TOWN PLANNING**1 SUBDIVISION OF LAND AT 46 TIVENDALE ROAD, OFFICER – DEFERRED ITEM**

That a Refusal to Grant Planning Permit T160693 be issued for a subdivision and associated works at 46 Tivendale Road, Officer on the following grounds:

APPLICATION NO: T160693

| PROPOSAL: | Staged subdivision and associated works |

Plan 5: Future Urban Structure

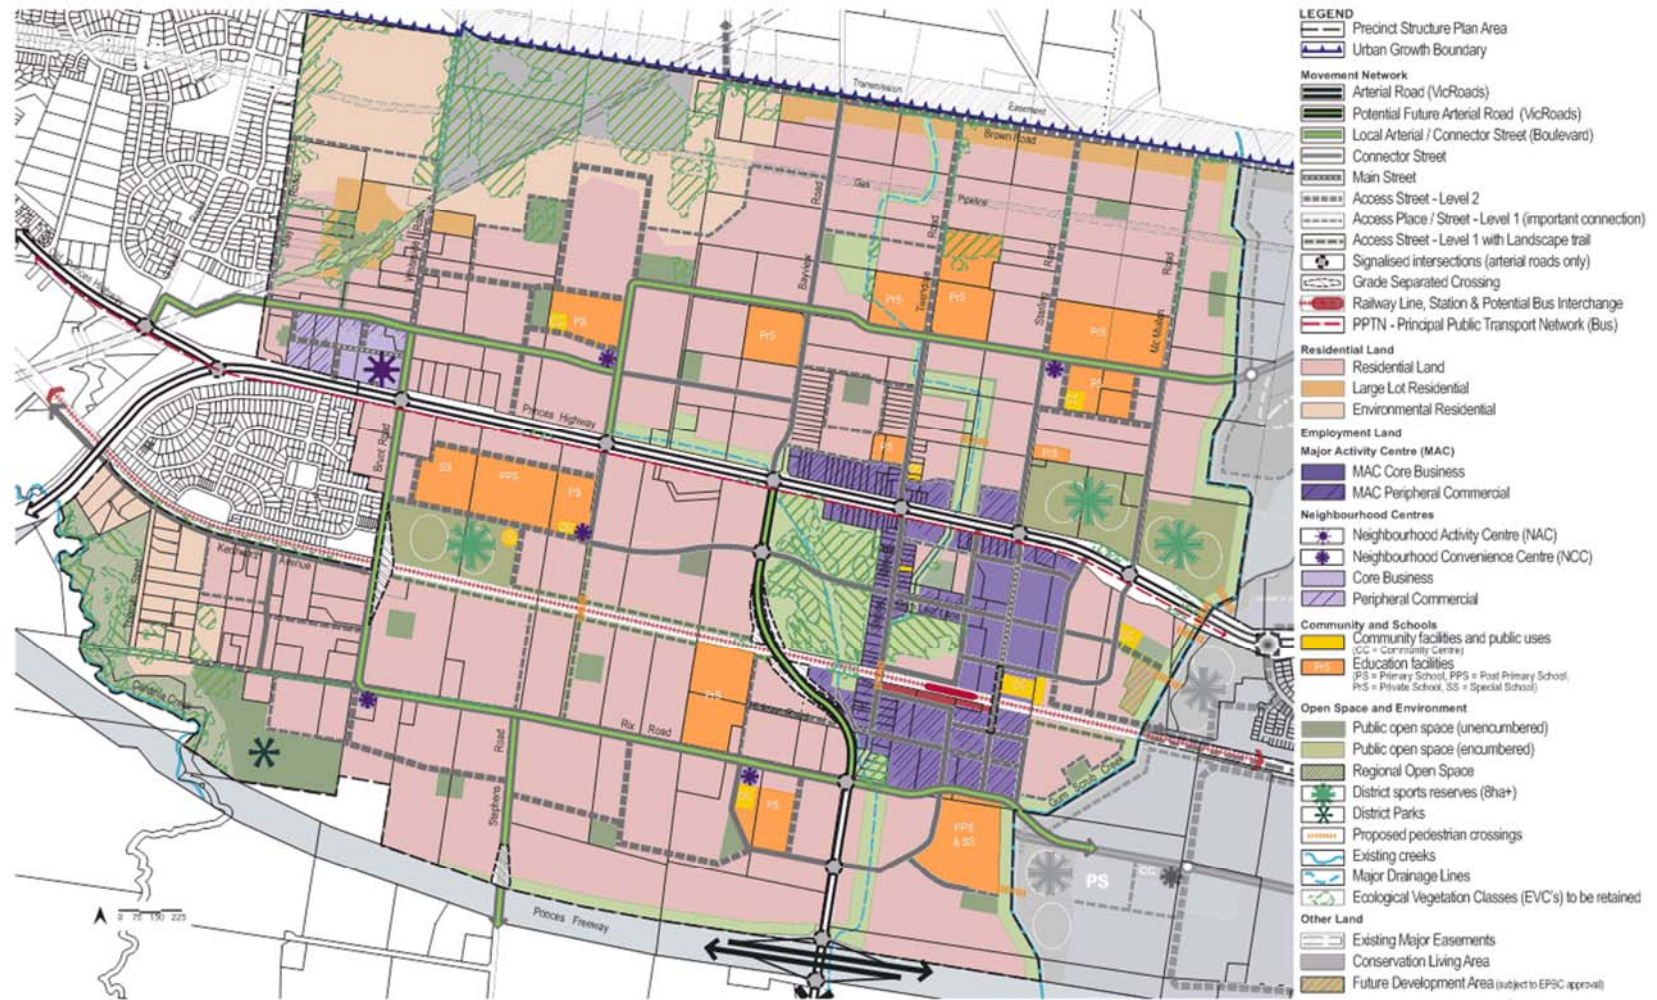
Plan 5 Future Urban Structure, describes how the PSP delivers the vision. It is considered that the proposed subdivision is not generally in accordance with plan 5 as the drainage corridor has been substantially reduced in size.

The reduction of the drainage corridor further inhibits the ability for the corridor to become a highly permeable and walkable open space trail network that the PSP envisages it to be.

Plan 6: Land Use Budget

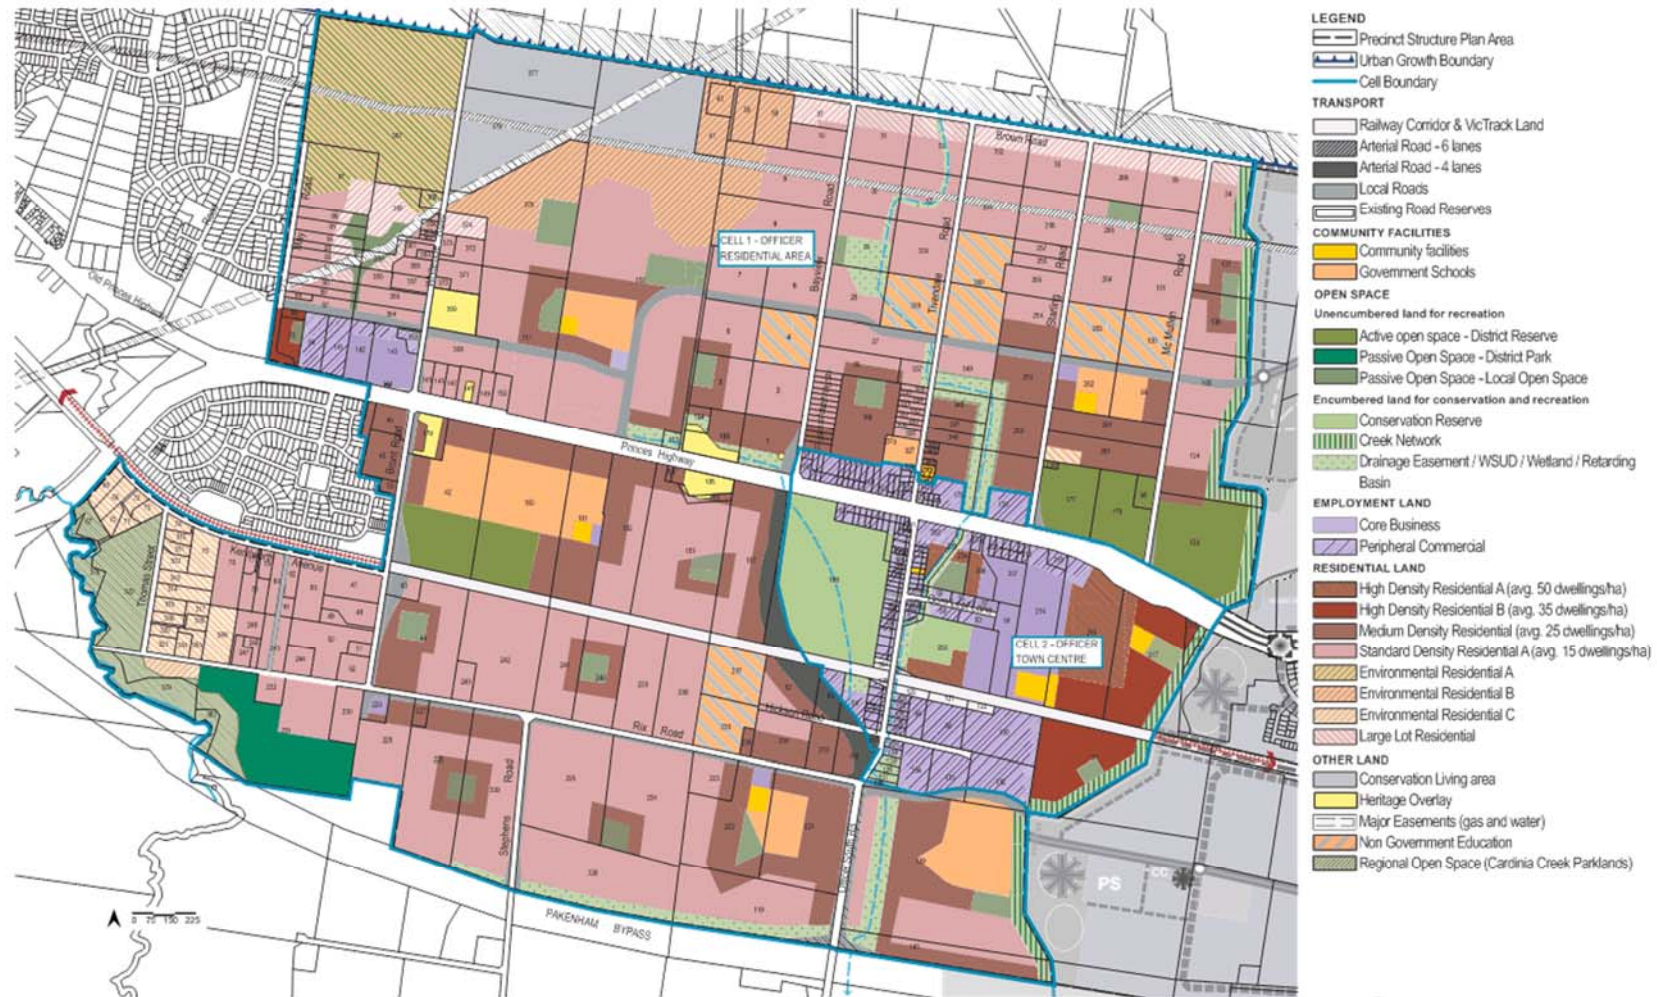
Plan 6 Officer Land Use Budget, the site is shown as property number 349.

- Local Roads Including Boulevard Connector - 0.69ha (not included in the net developable area - NDA)
- Drainage easement/WSUD/Wetland/Retarding Basin – 1.19ha (not included in the NDA or OS%)
- Local Open Space – 0.21ha (not included in the NDA or OS%)
- Total property area 4.02h and total NDA – 1.93ha

In response to the above, the proposal does not comply with the land use budget as the areas as described above have not been achieved within the proposed plan. The most concerning figure is the applicant is proposing to only deliver 4,370sqm of drainage easement/WSUD/wetland/Retarding Basin land instead of the approximately required 11,190sqm required by the PSP

Plan 11: Open Space Network

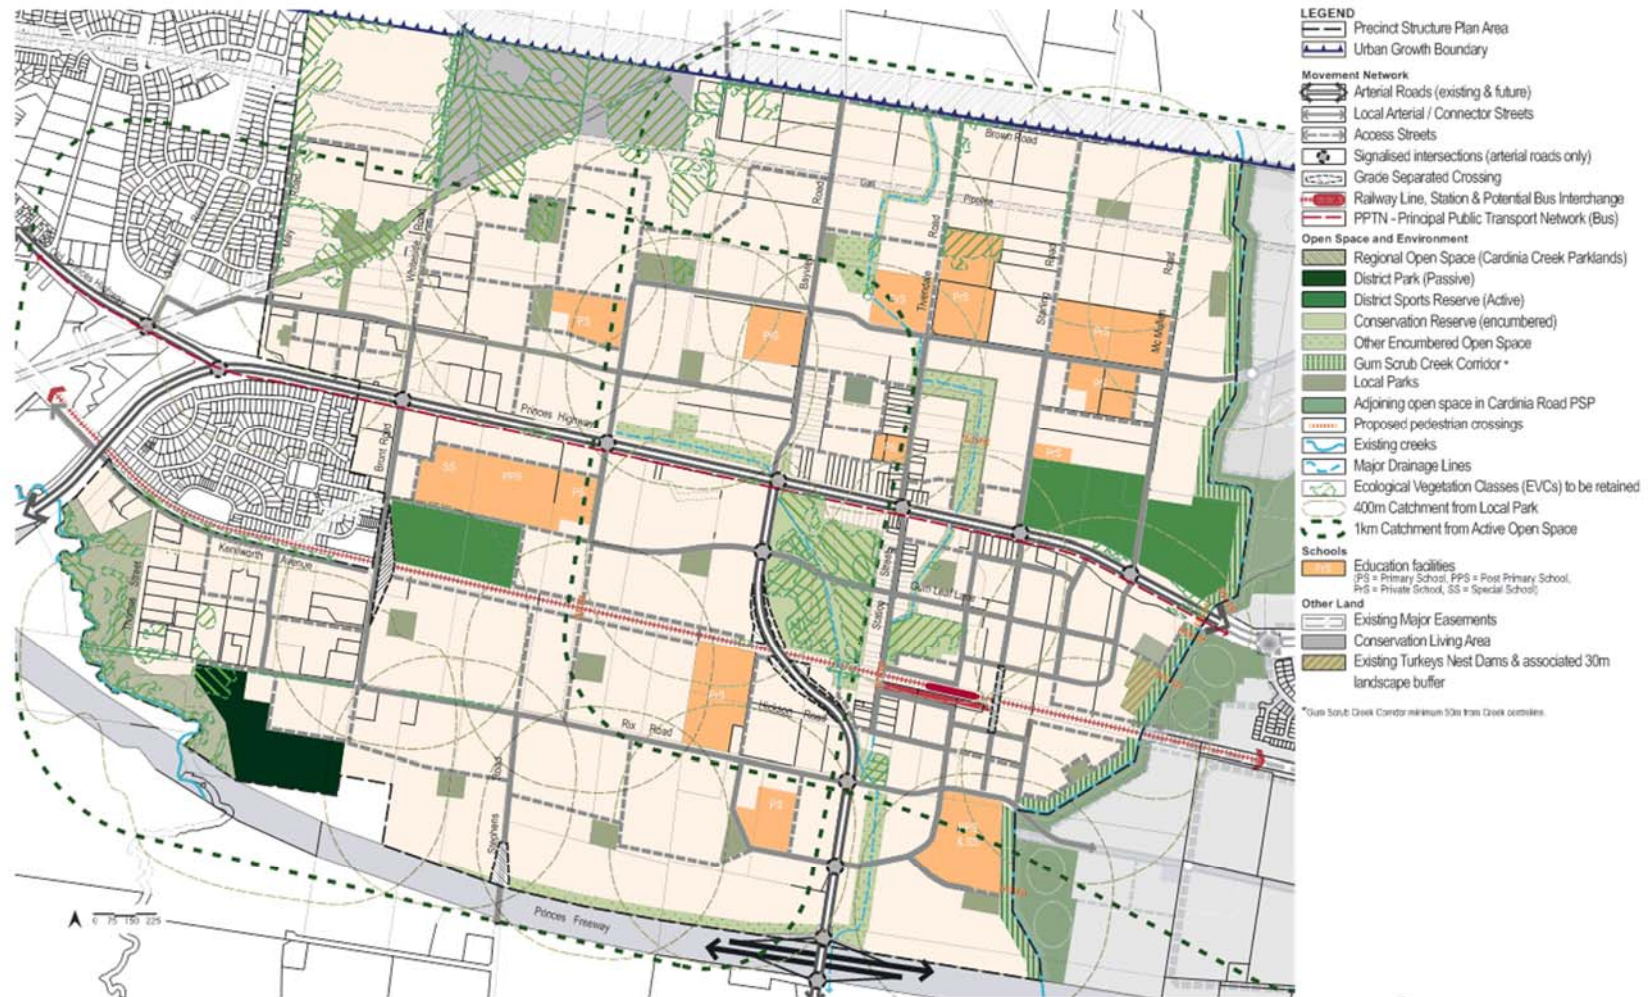
Plan 11 Open Space Network identifies the site as being partly encumbered and encumbered public open space with a major drainage line.

In response to the above, it is considered that the proposal fails to meet the relevant planning and design guidelines to be met as the reduction of the drainage corridor does not allow for the adjoining retarding basins to be well aligned and integrated into the broader open space network. The subdivision layout proposes a reserve that is inconsistent in width and function with the remainder of this drainage reserve and other reserves in Officer. The network is intended to be consistent through each site as shown within the PSP.

Plan 12: Integrated Water Management

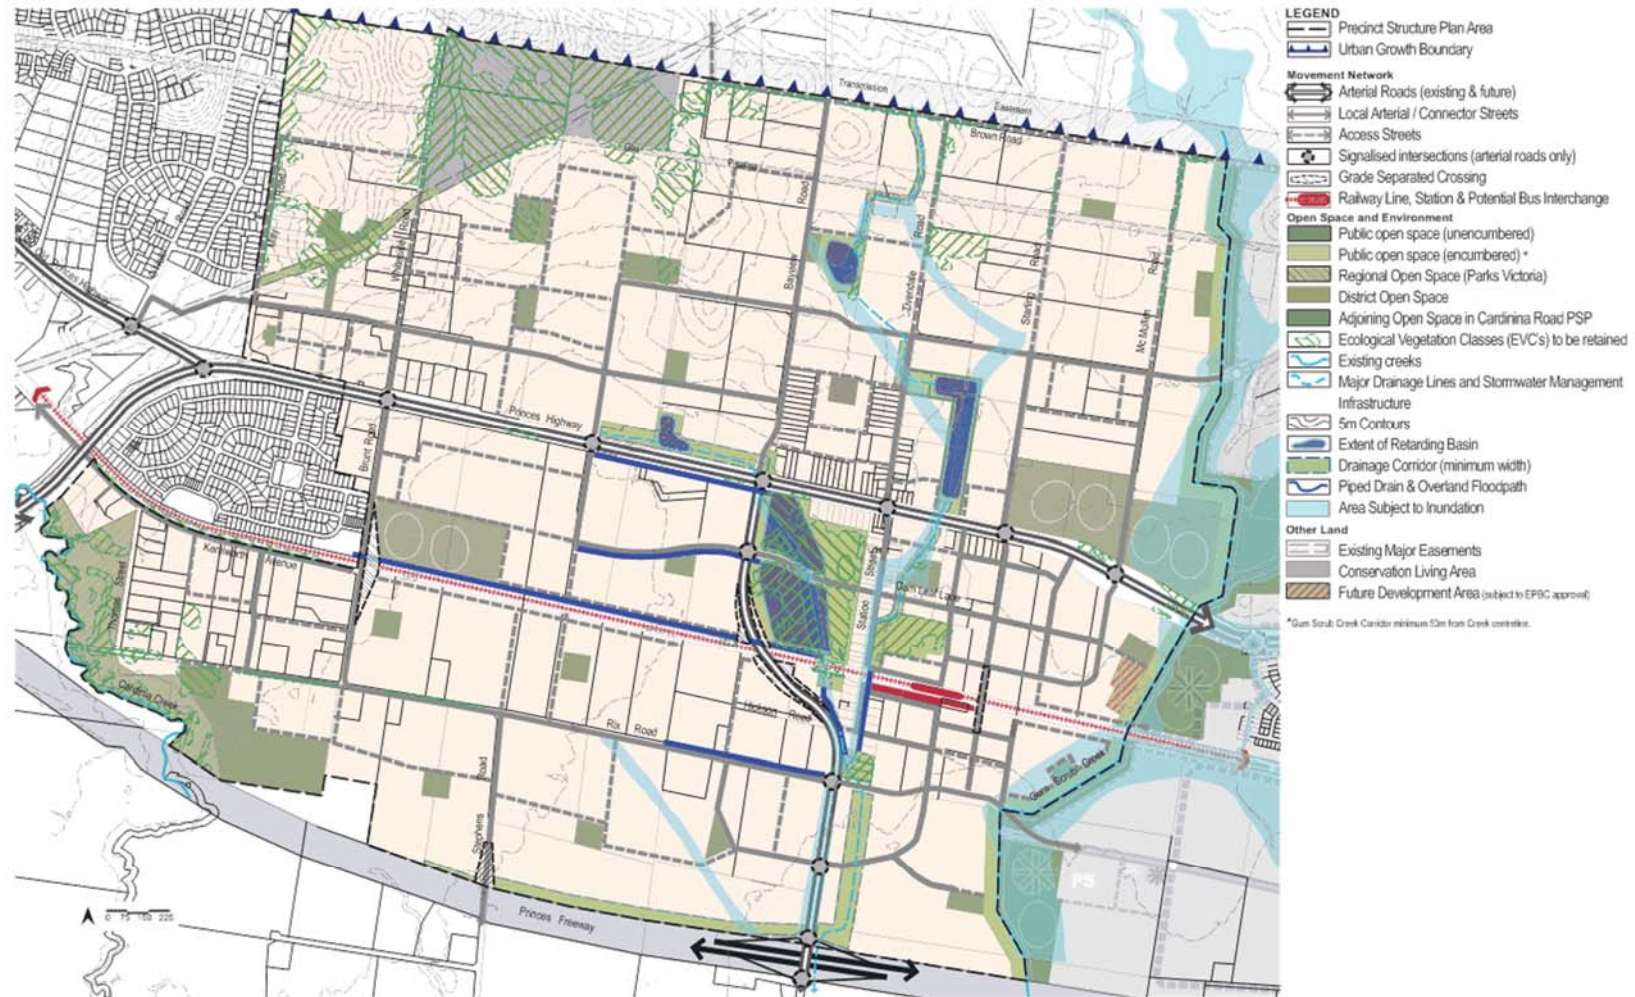
Plan 12 Integrated Water Management identifies the site as being part of a wider drainage corridor and having a retarding basin within it. The south west corner of the land is identified within the land subject to inundation overlay over it.

The area subject to inundation and drainage corridor extends from the north to the south of the Officer PSP boundary. The drainage corridor follows a specific drainage line that meets with retarding basins and open space. The role of encumbered land is to provide for overland flows and stormwater retention and to maintain access to services.

Plan 17: Walking and Trails

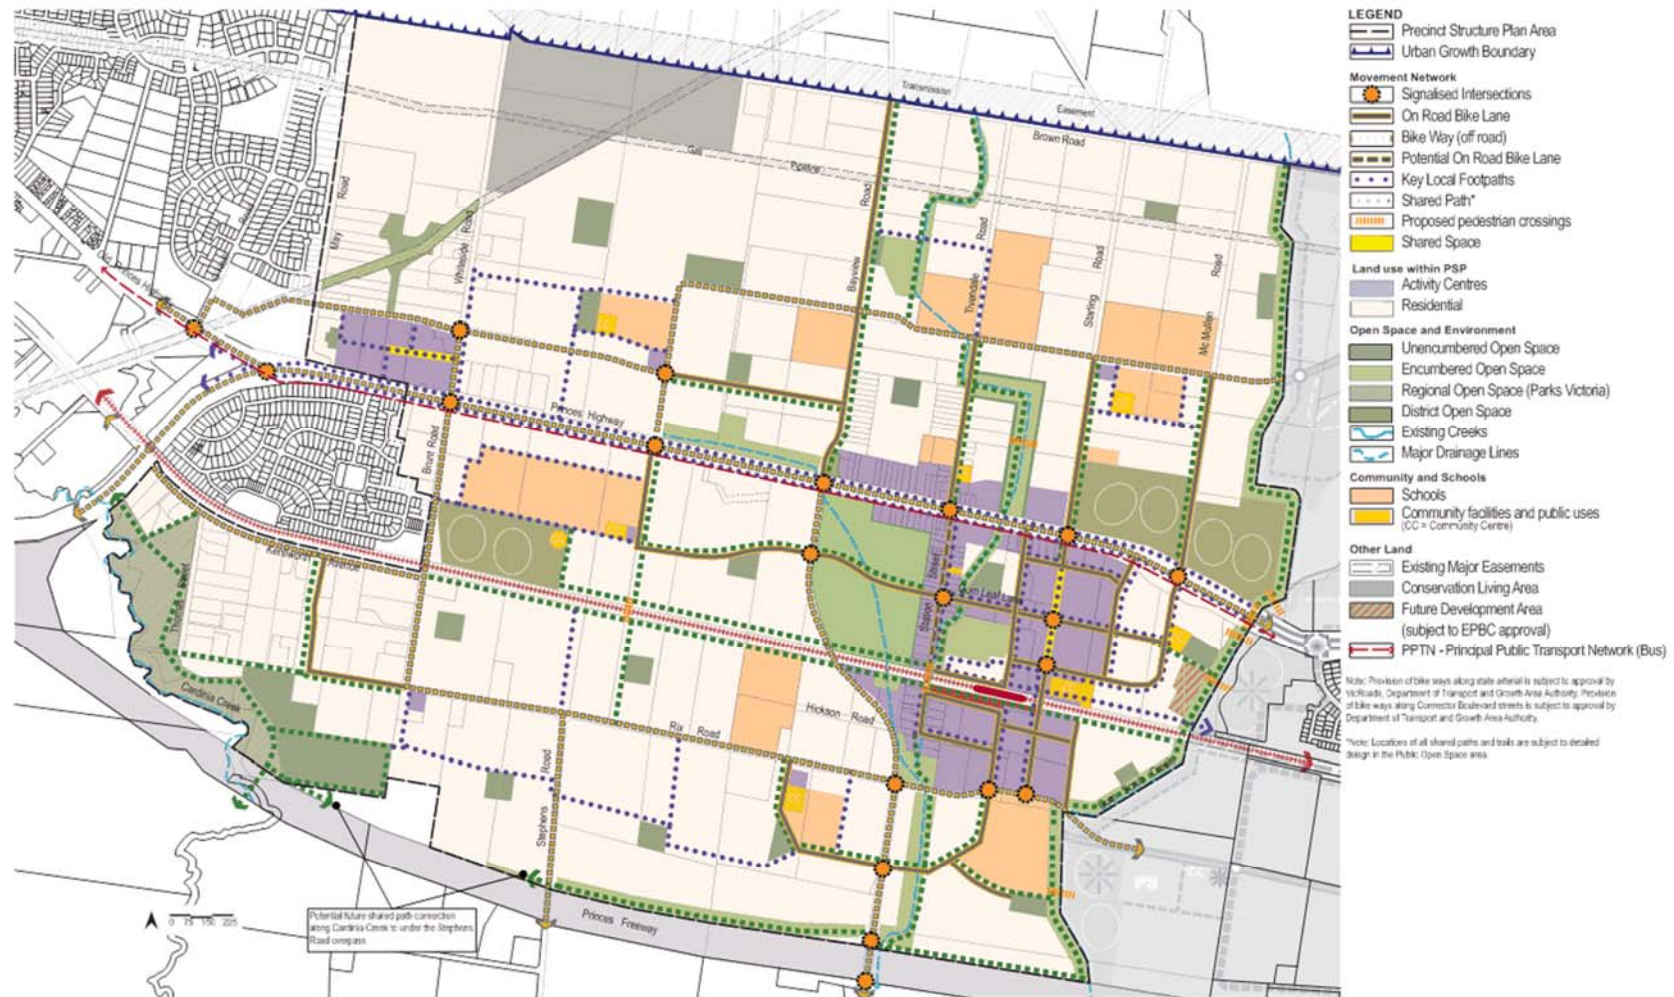
Plan 17 Walking and Trails shows a shared path within Tivendale Road and within the drainage corridor.

- Provide a 2.5 metre wide shared path along and within the open space network, in particular along the creek/drainage network.

In response to the above, a 2.5 metre wide shared path along and within the open space network, in particular along the drainage network and provision of landscaping must be provided to achieve the objectives of the PSP, at present the reduction of the drainage corridor fails to achieve these outcomes.
